ADDENDUM NO. 1
FOR
CONTRACT NO. 3 – WATER LINE EXTENSIONS ALONG COUNTY ROADS 644 AND 826
FOR
THE CLEBURNE COUNTY COMMISSION
CDBG PROJECT NO. CY-CM-PF-20-009
NOVEMBER 13, 2024

SUBJECT: Plans, Specifications and Contract Documents are hereby amended, modified, and changed as follows:

ADDENDUM NO. 1

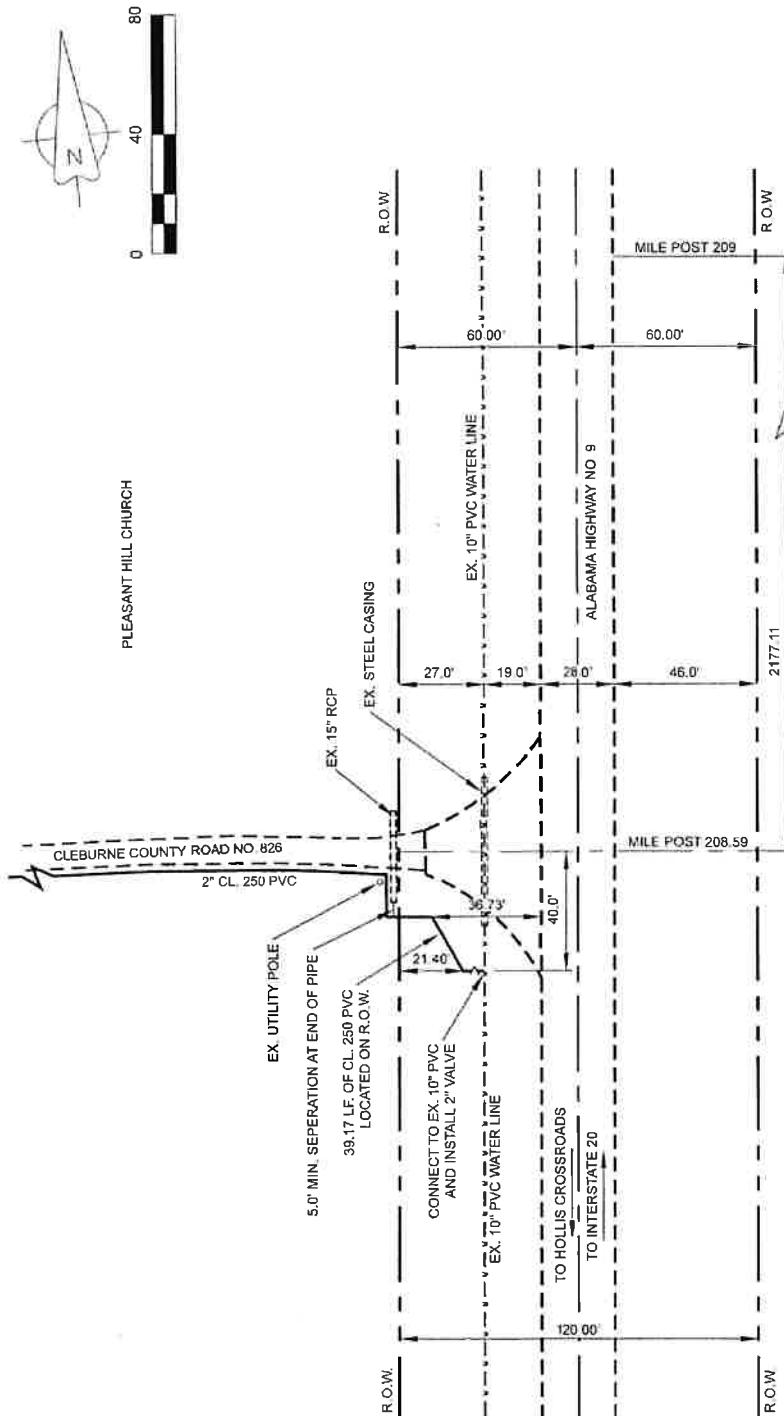
- II. Reference Exhibit "A"
 - A. Replace Sheet A-8 with the attached marked ADDENDUM NO. 1 on page ADM1-3.
- III. Reference Plan Sheet 3
 - A. The existing water line on County Road 96 where the connection at County Road 644 will occur may be a 2" or a 2-1/2" water line. Contractor shall cut in a 3" tee with adapters as required to connect to the existing line and the proposed 2" valve.
